ABB Seismic/LOCA Evaluation Methodology for Boiling Water Fuel

CENPD-288-NP-A

SUBJECT: ACCEPTANCE FOR REFERENCING OF TOPICAL REPORT CENPD-288-P,
"ABB SEISMIC/LOCA EVALUATION METHODOLOGY FOR BOILING WATER FUEL,"
(TAC NO. M89663)

APPENDIX B: RESPONSES TO REQUESTS FOR ADDITIONAL INFORMATION

Figure B6-1 Comparison of BWR Fully Recrystallized Annealed Zircaloy-2 Ultimate Strength Acceptance Limit with Measured Data.

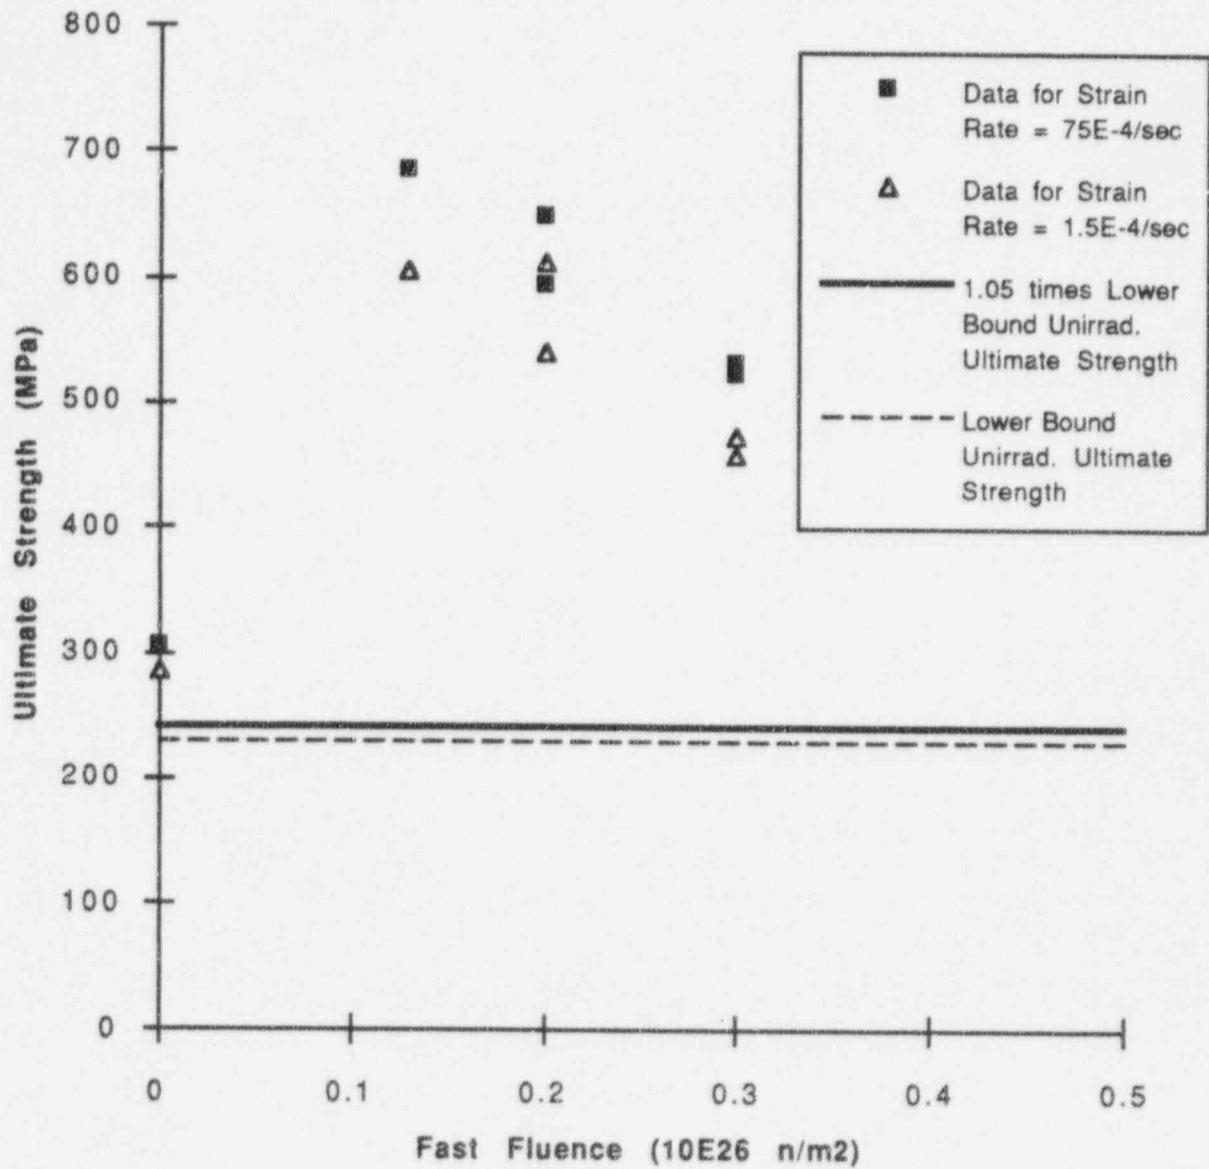
NRC Question B6

ABB Response to Question B6

The methodology described in the main body will ensure that irradiated fuel assemblies will not fracture if subjected to SSE plus LOCA loads. For example, a SVEA-96 fuel assembly is composed of a Zircaloy-4 channel, Zircaloy-2 fuel rods, and stainless steel castings for the bundle and channel end pieces. The stainless steel castings are of relatively solid design and have very large strength margins. Therefore, the focus of this response concerns the Zircaloy components.

ultimate strength occurs early in the fast fluence exposure, so that it is reasonable to extend the data to fast fluences greater than 1×10^{26} n/m². This extrapolation is supported by the data reported in Reference B17 (Yasuda, et al.) which indicate most of the increase in yield strength of fully recrystallized annealed Zircaloy-2 occurs below a fast fluence exposure of 10^{24} n/m², and no significant change in the fluence dependency is exhibited up to 0.4×10^{26} n/m². These data support the qualification of the Zircaloy material models discussed in Appendix A of Reference B8. The data confirm that the reduction in material ductility with irradiation is not of concern (see Figure B6-1), since the irradiated ultimate strengths far exceed the acceptance stress intensity limit established from the lower bound of the unirradiated strength (given in Table 6.1C of this report).
